Title	Display is switching from cubed/crushed on its own without being touched		
Create Date	4/12/2017	Service Bulletin Number	ASC20170412001
Revision Date	6/12/2017	Models RF28HFEDT, RF28HFEDB RF28HMEDB, RF25HMEDB RF28HDEDT, RF28HDEDB	AW2, AW3, AW4
Symptom	LED Panel	Display switching	Crushed to Cubed

Pictured Above: Photos of the DA97-1309G Twin Icemaker Control and the DA97-1390F Single Icemaker Control. The DA-1309G has a green sticker (circled). The DA-13890F has a red sticker (circled). Make sure the Icemaker you ordered has the correct sticker when it arrives.

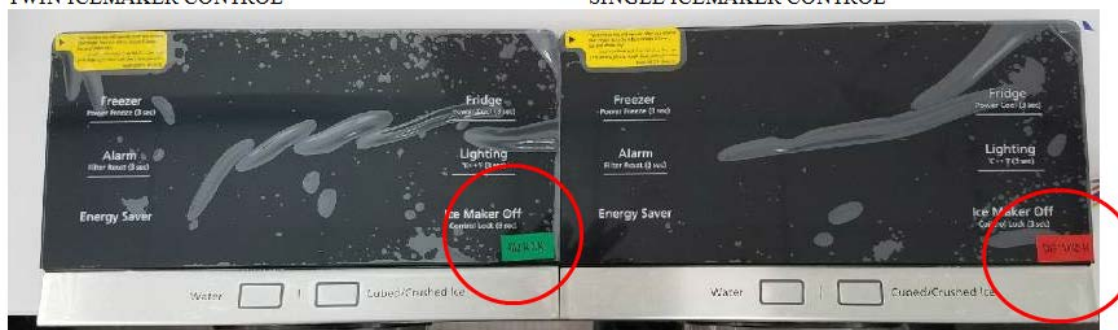
Intermittent electrical noise between the Display Touch IC and the door plate.

Produce a new Touch IC that has enough margin.

Replace the existing Assy - Cover Dispenser with the new, improved Assy - Cover Dispenser.
